SU1474800000B	INDIAN RIVER FARMS LAKE #2	. 979832. 2017-04-11

Created	2017-04-02 01:57:11 UTC by Jaime Parson
Updated	2017-06-20 14:03:08 UTC by Michelle Karpaitis
Location	36.7479382274851, -76.1265877750949
Status	Complete
Overall Information	
HIGHEST SCORE	2
Inspector	Michelle Karpaitis
Team	Team 2
Compkey	979832
UnitID	SU1474800000B
SWMF_Name	INDIAN RIVER FARMS LAKE #2
Date	2017-04-11
Time	09:52
Weather	Sunny, Windy, Mild
Rainfall	No Rain
Address	2548 Belmont Stakes Dr Virginia Beach, VA 23456
Ownership GIS	P-FQ
General Comments	Several small pipes and hoses appear to be draining into pond from pools, may be causing slope erosion. Pond has steep slope. Rip rap around water's edge seems to help with erosion. Grass filter strip was sparse around pond. There is evidence of a filter strip, but the grasses are cut too short. Woody vegetation in several areas along slope of pond. Patches of bare soil in some locations around pond. Some carving of the slope near the end of the pond at the riser spillway. Flow channel leading to a sinkhole on the slope. Aquatic vegetation growing inside of inlet F12509-1033. Could cause a clogging issue in the future. Also, woody vegetation growing ar

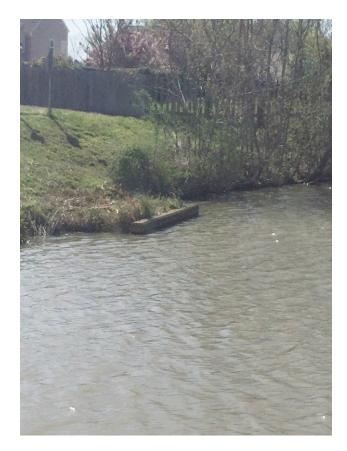
Side Slope Comment	Large depression on side slope	
Erosion		
Side Slope Defect Type	Erosion	
Side Slone Defect Type Score	2 = Degraded condition, Poorly maintained, routing maintenance and repairs needed

Side Slope Comment	24" hole in side slope with upstream bank erosion.
3 - First Highest Side Slope Score and Defect type	2 - Erosion
3 - First Highest Side Slope Score	2
4 - EMBANKMENT INSPECTED	N/A
4 - First Highest Embankment Score and Defect Type	0 -
4 - First Highest Embankment Score	0
5 - RISER PRINCIPAL SPILLWAY INSPECTED	Yes
Riser Principal Spillway Defect Type Score	0 = Good condition. Well maintained, no action required.
Riser Principal Spillway Comment	F12509-1025 Shown on field map as a storm node.
5 - First Highest Riser Principal Spillway Score and Defect type	0 -
5 - First Highest Riser Principal Spillway Score	0
	0
6 - INLET INSPECTED	Partial see comments
